IMAX Redevelopment

SSD 5397

Submission to NSW Department of Planning and Infrastructure
28 October 2013

City of Sydney

Figure 3. First design intent lodged with DGRs request
Source: Proponent's DGRs drawings

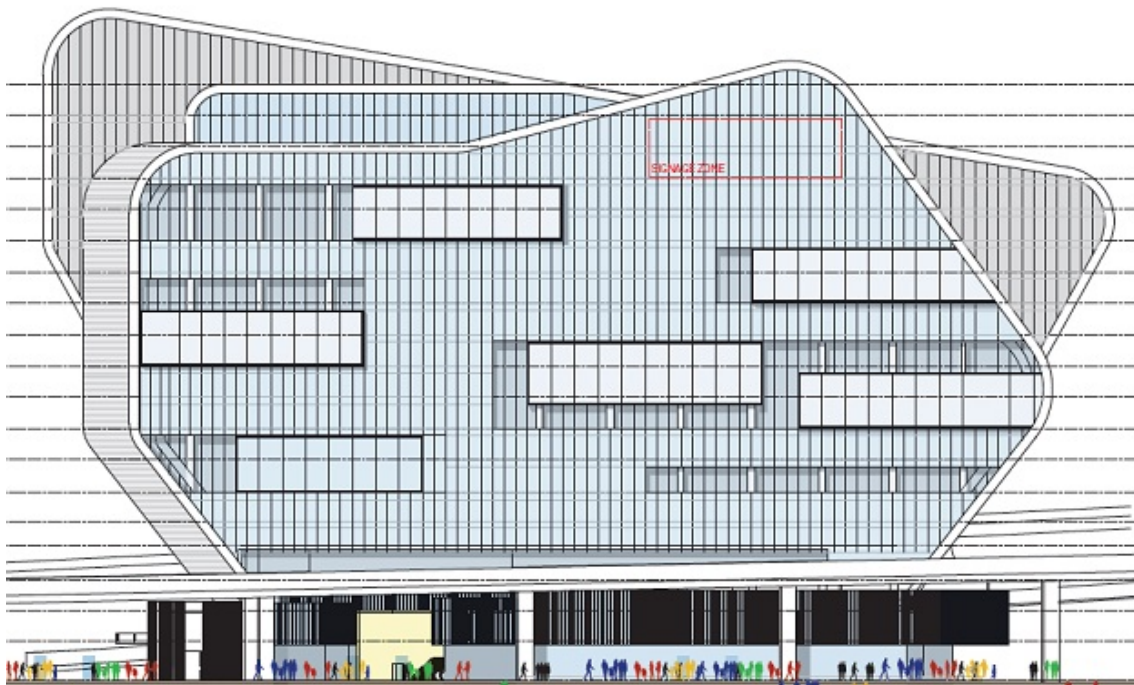
The City's response to the draft DGRs for the original design raised issues with the bulk and scale of the proposal. Among the issues raised in the DGRs response was that the proposal was a number of floors too high and the footprint at the ground was too large and disruptive to pedestrian flows through the site. In relation to height, it was felt that the proposal would have resulted in significant loss of solar access to the Darling Quarter children's playground and Tumbalong Park from the western corner of the building.
